**NORTH & SOUTH SEAWALL at WEBHANNET DRIVE  
WELLS, MAINE  
D&K Project No. 627789P5**

**ADDENDUM NO. 1**

July 17, 2023

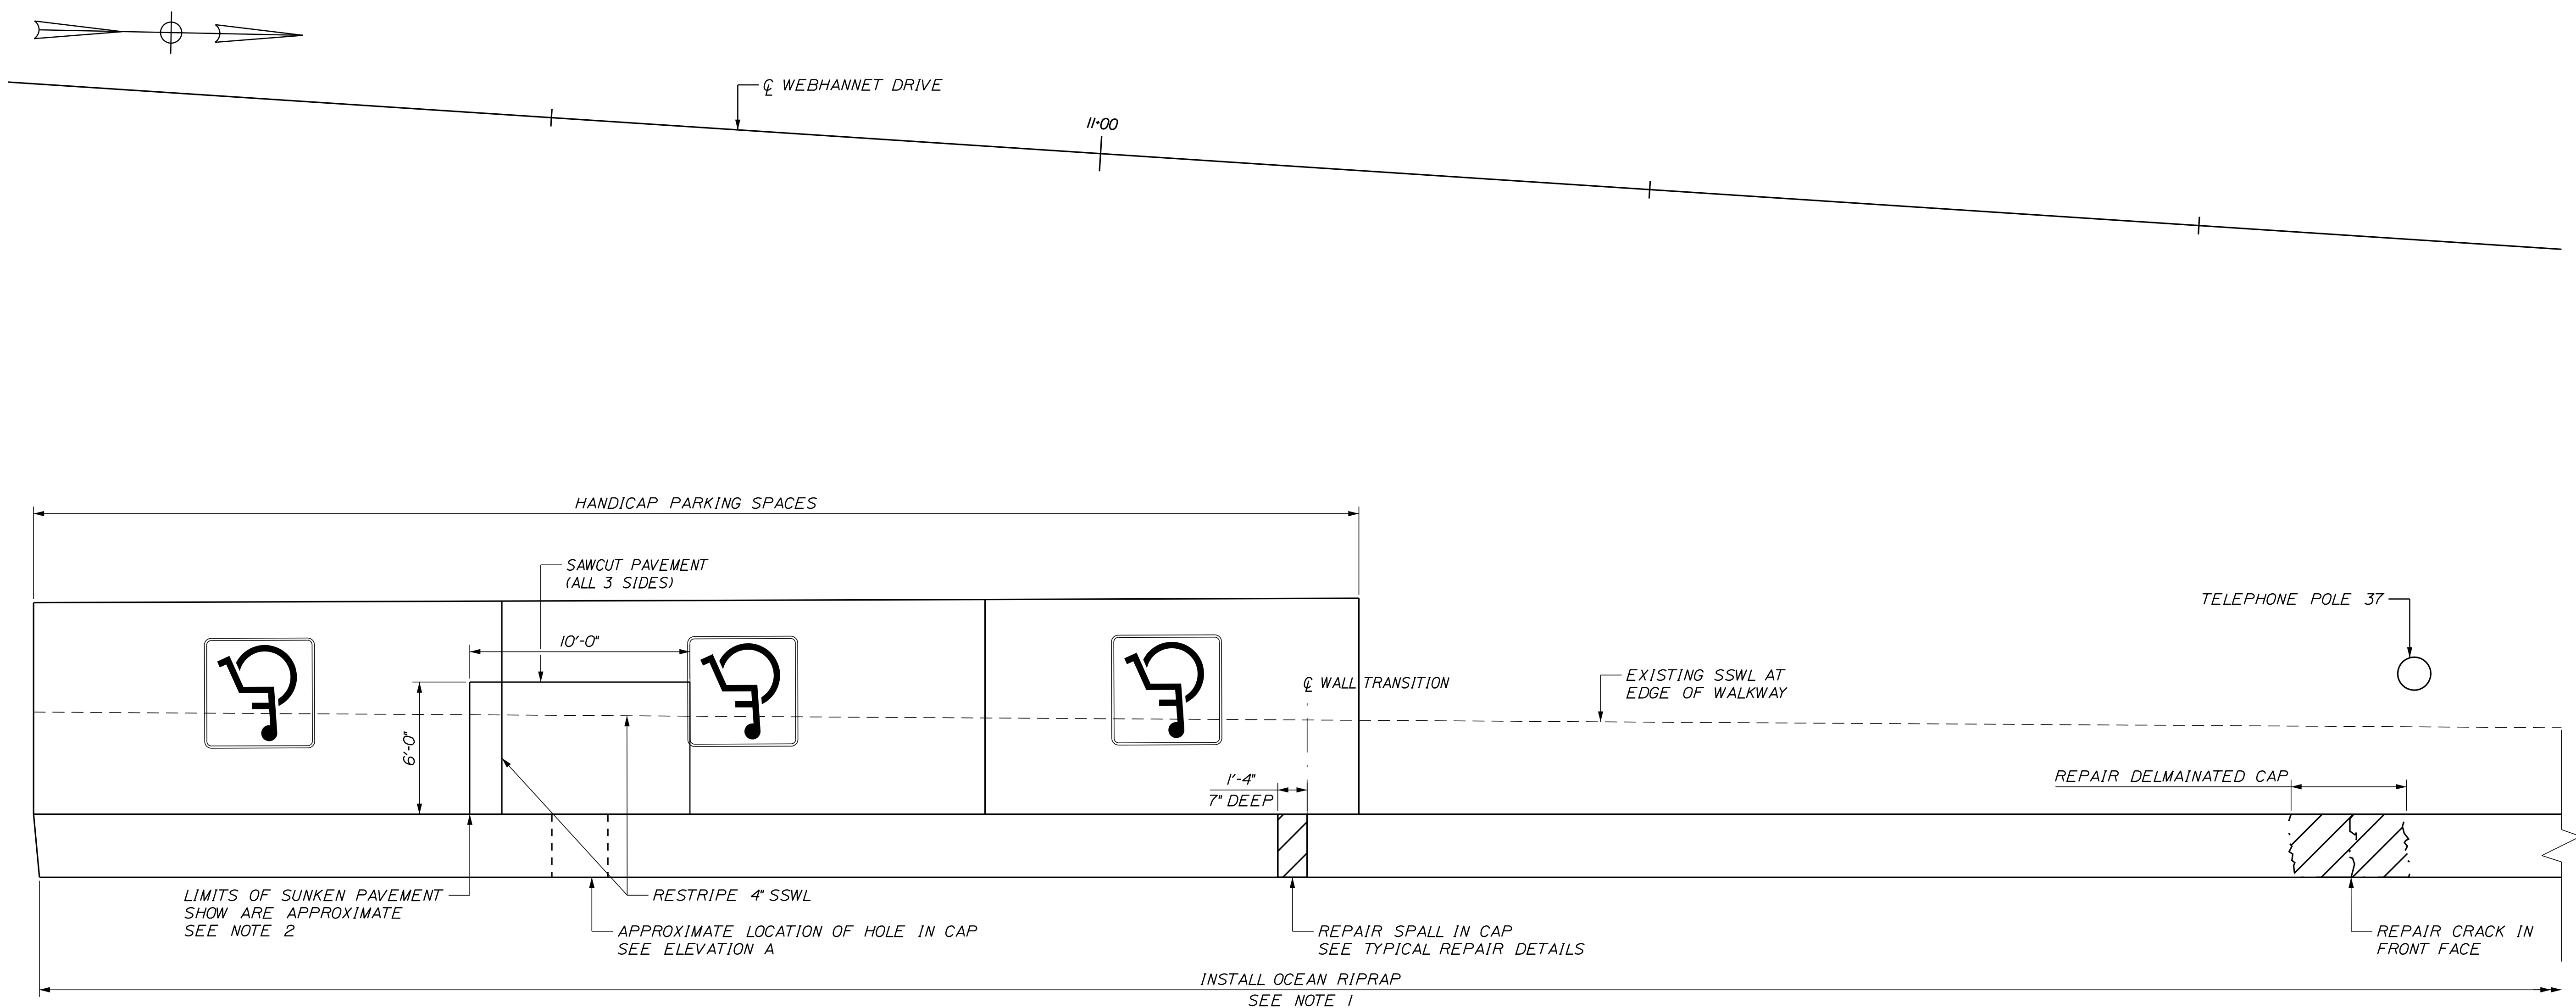
B. SHEET 9 – SOUTH WALL REPAIR PLAN 1

1. ELEVATION A - REMOVAL– **Revise** detail as follows:

**INCLUDE** dimension with text that reads REPAIR LIMITS (ITEM 518.61).

ELEVATION B REMOVAL  
N.T.S.

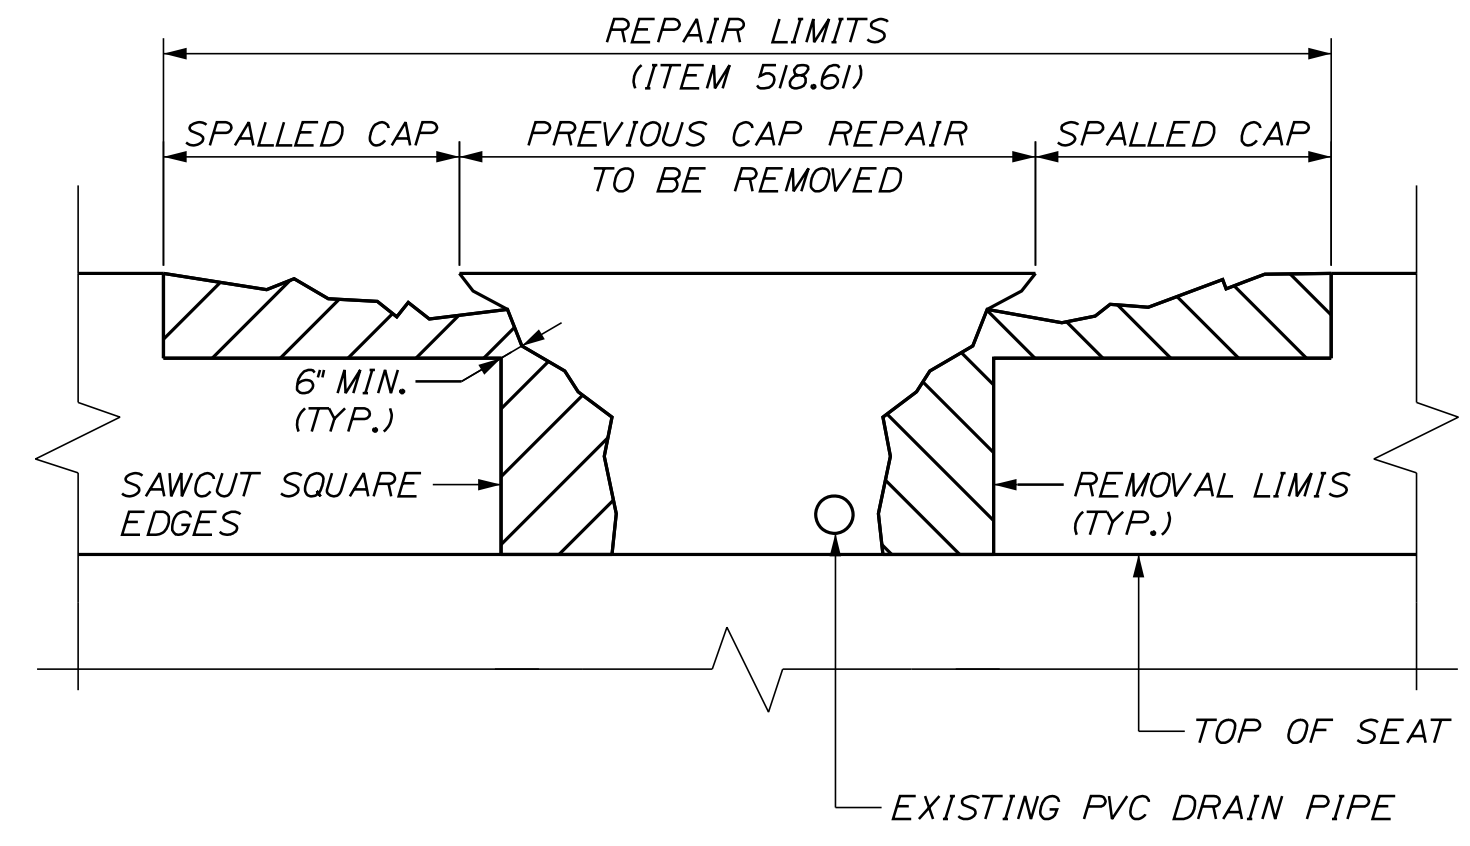
C. SHEET 11 – SOUTH WALL REPAIR PLAN 3

1. ELEVATION B - REMOVAL– **Revise** detail as follows:

**INCLUDE** dimension with text that reads REPAIR LIMITS (ITEM 518.61).

CAP REPAIR  
REMOVAL LIMITS

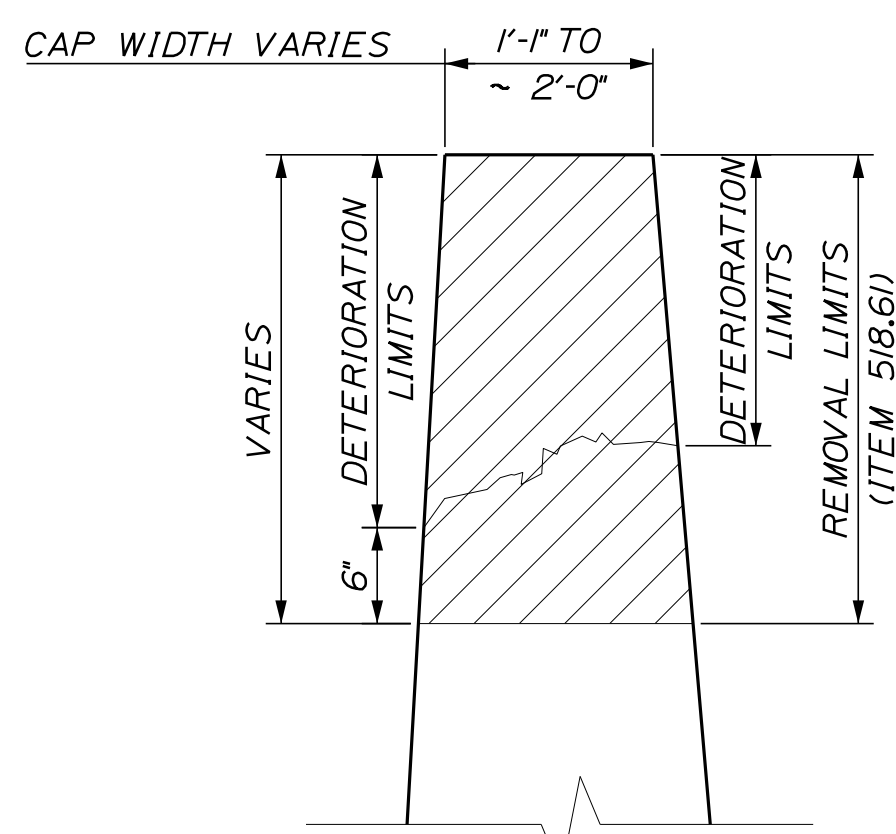
D. SHEET 13 – REPAIR DETAILS 1 OF 2

1. CAP REPAIR REMOVAL LIMITS– **Revise** detail as follows:

Q6) In reference to Items 502.3413, Item 518.60 and Item 518.61, can these item numbers be referenced on the corresponding repair detail shown on sheet 13 and 14?

**INCLUDE** dimension with text that reads REMOVAL LIMITS (ITEM 518.61).

A) Item 502.3413 shall be used for sonotubes as necessary (see Note 1, Sheet 4). Items 518.60 & 518.61 shall be used for concrete repairs shown on sheet 13 that are not crack repairs, and the stem face repairs as shown on sheet 14. The actual item used for these repairs depends on if the depth of the repair extends more than 8" or not. Item 518.51 shall be used for the stem seat repairs as shown on sheet 14. Item 502.605 shall only be used as shown on the South Wall Typical Cross Section, shown on Sheet 15.

TYPICAL STEM FACE REMOVAL  
SCALE: 1" = 1'-0"

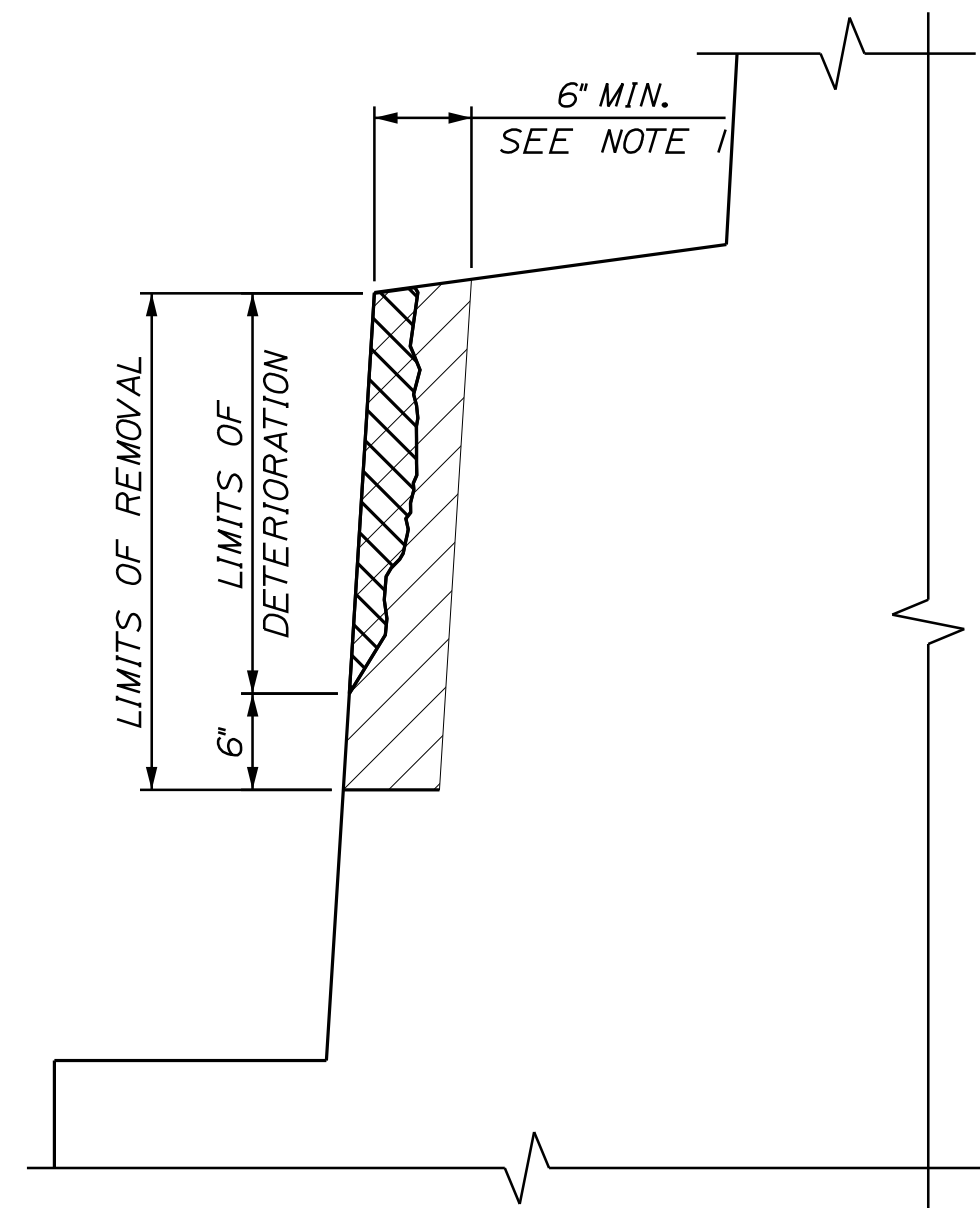
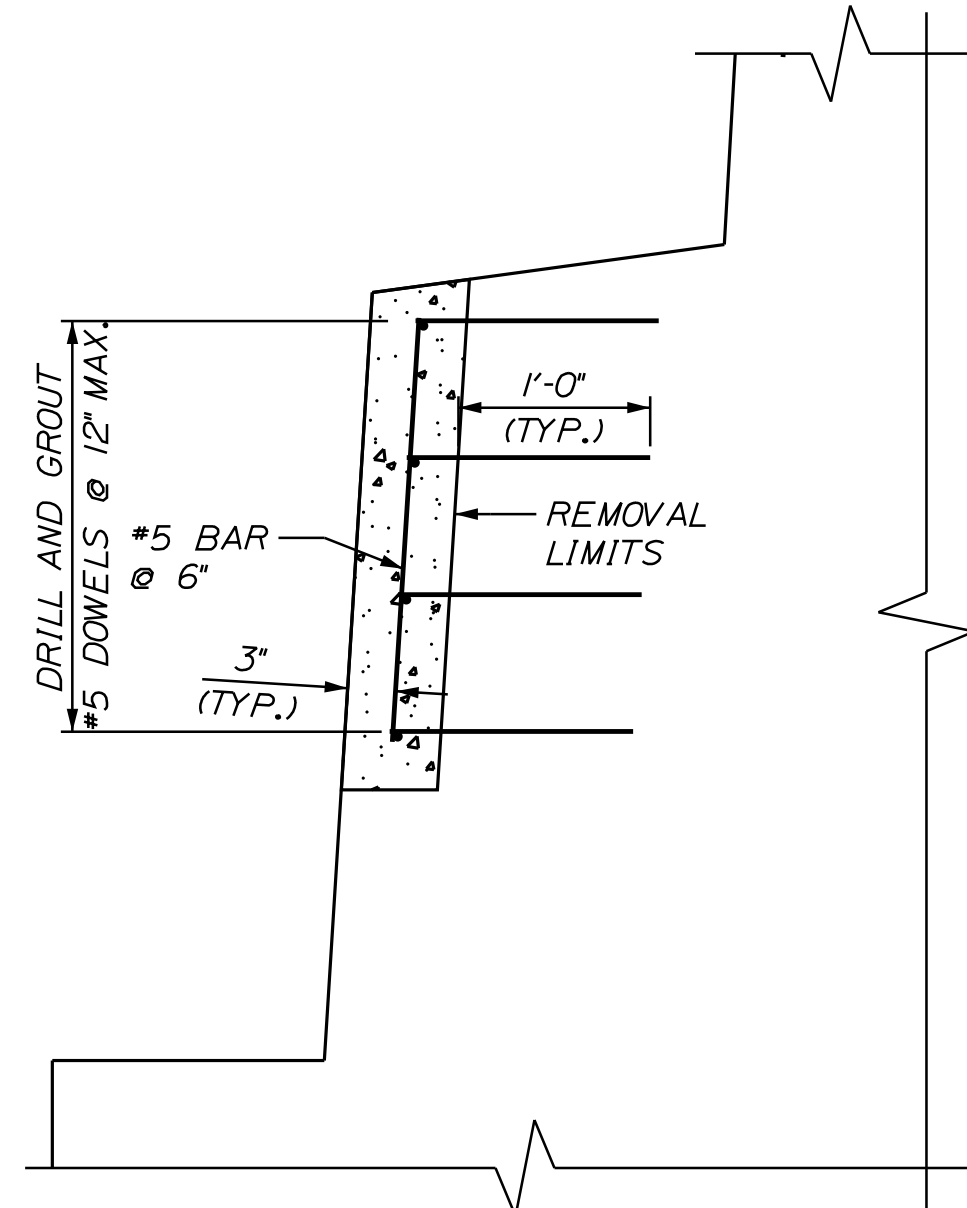
E. SHEET 14 – REPAIR DETAILS 2 OF 2

1. CAP REPAIR REMOVAL LIMITS– **Revise** detail as follows:

2. NOTES– **Include** note 6 as follows:

**INCLUDE** callout with text that reads REMOVAL LIMITS (ITEM 518.61).

**INCLUDE** note that reads “STEM FACE REPAIR SHALL BE PAID FOR UNDER ITEM 518.60 OR ITEM 518.61 DEPENDING ON THE DEPTH OF REMOVAL. WHERE THE REPAIR DEPTH IS LESS THAN 8" PAYMENT SHALL BE MADE UNDER ITEM 518.60. WHERE THE REPAIR EXTENDS 8" OR GREATER, PAYMENT SHALL BE MADE UNDER ITEM 518.61.”
